August 10, 2023

Version 3

Product Update: 2022 CR-V EPS Gearbox ReplacementSupersedes 22-011, dated March 3, 2023, to revise the information highlighted in **yellow**.**AFFECTED VEHICLES**

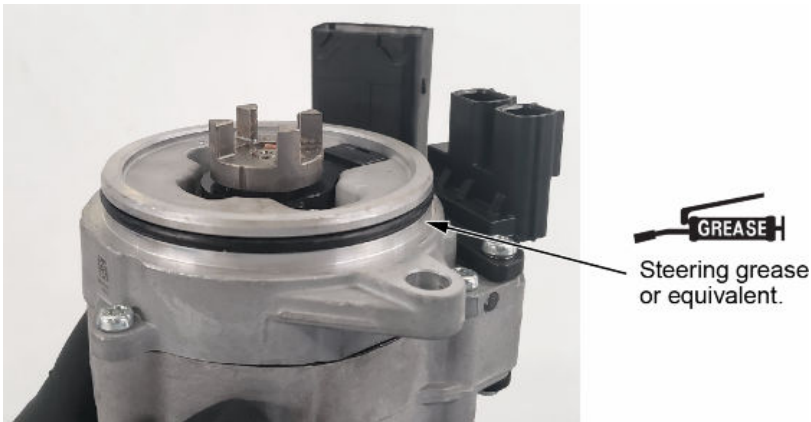
Under REPAIR PROCEDURE, steps 22 through 23.5 was updated.

22. Remove the EPS motor/control unit and discard the motor bushing, rubber bushing, O-ring, and flange bolts.

23. Install the EPS motor/control unit onto the new P/S gearbox using the new replacement parts included in the kit:

NOTE: The motor bushing and rubber bushing are greased and installed in the new gearbox.

Description	Quantity
Motor O-ring (79.4 x 3.1)	1
Flange Bolt (8 x 30)	2
Motor Bushing	1
Rubber Bushing	1

EPS MOTOR CONTROL UNIT
Turn unit two or three times to the right and left (about 45 degrees).

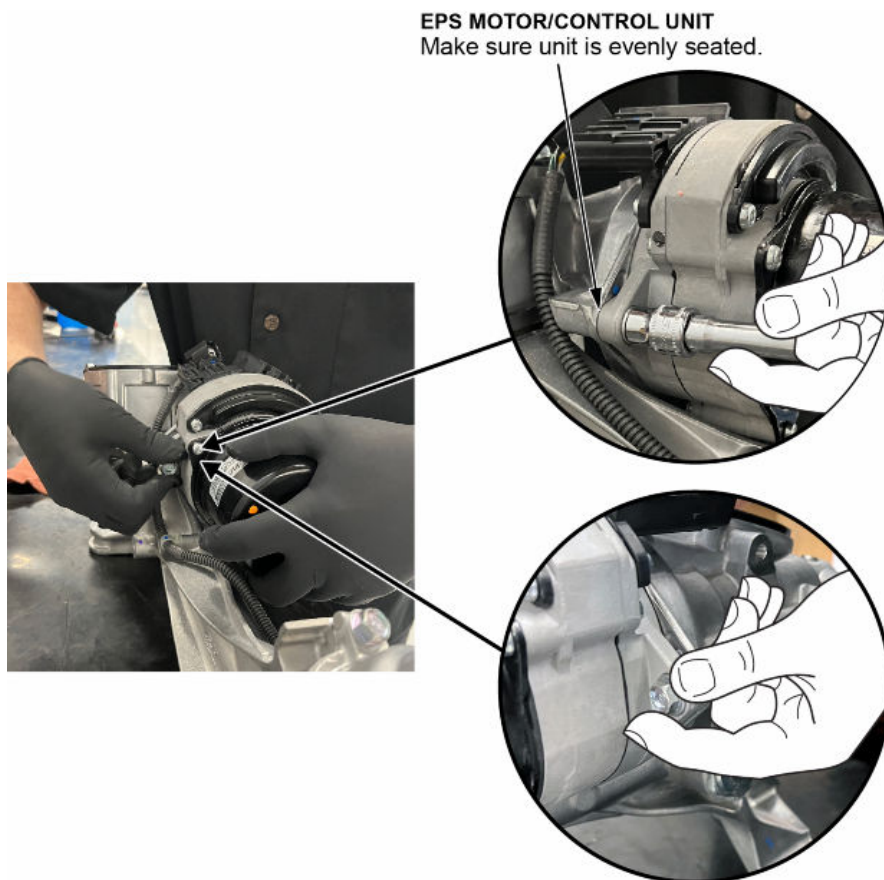
23.1. Apply steering grease or equivalent on the new O-ring and install it onto the EPS motor/control unit.

23.2. Install the EPS motor/control unit, but do not install the mounting bolts.

23.3. Turn the EPS motor/control unit two or three times to the right and left about 45 degrees.

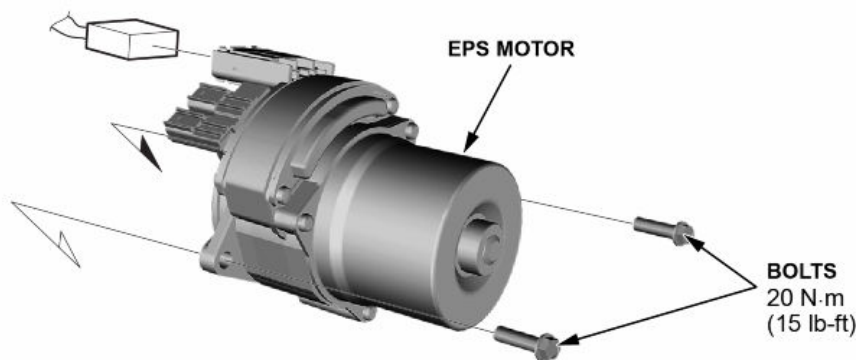
23.4. Loosely install the new EPS motor/control unit mounting bolts by hand but do not tighten.

NOTE:

- To prevent damaging the motor and/or gearbox, DO NOT use power tools to install or tighten the bolts.
- Make sure the EPS motor/control unit is evenly seated on the P/S Gearbox.

23.5. Tighten the EPS motor/control unit mounting bolts to 20 N·M (15 lb-ft).
